PRODUCT CHANGE NOTIFICATION

Bourns® 1220 Series UL 1449 Surge Protection Device (SPD)

Type Upgrade

SPD2603

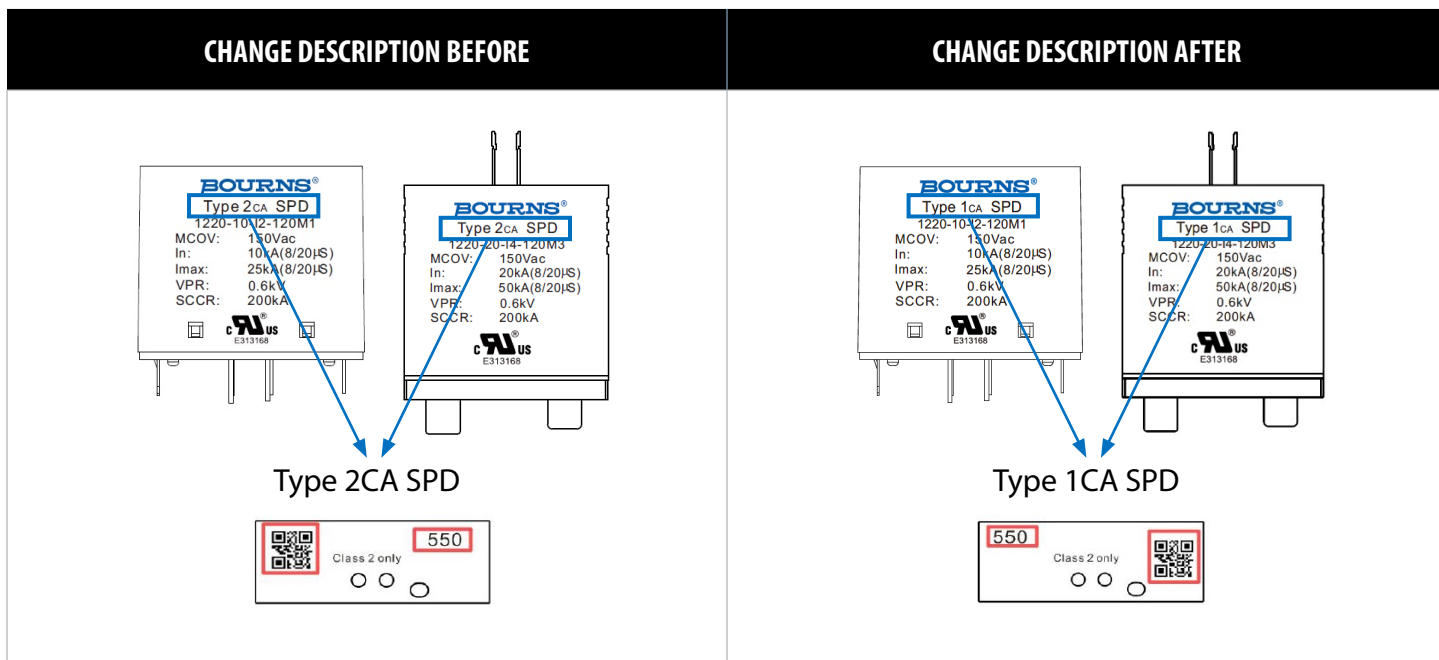
This change to UL 1449 SPD Type will affect the product's form. The printed marking on the module of the affected part numbers will change from "Type 2CA" to "Type 1CA". To improve readability, the position of the markings printed on the top of the casing has been adjusted. The fit, function, quality, and reliability of the affected part numbers will remain unchanged. Traceability will be maintained through lot code and date code.

Implementation dates are as follows:

Date that the use of the current packaging will cease: **August 31, 2026**

Date that the use of the new packaging will begin: **September 1, 2026**

First date codes using the above changes: **2635**
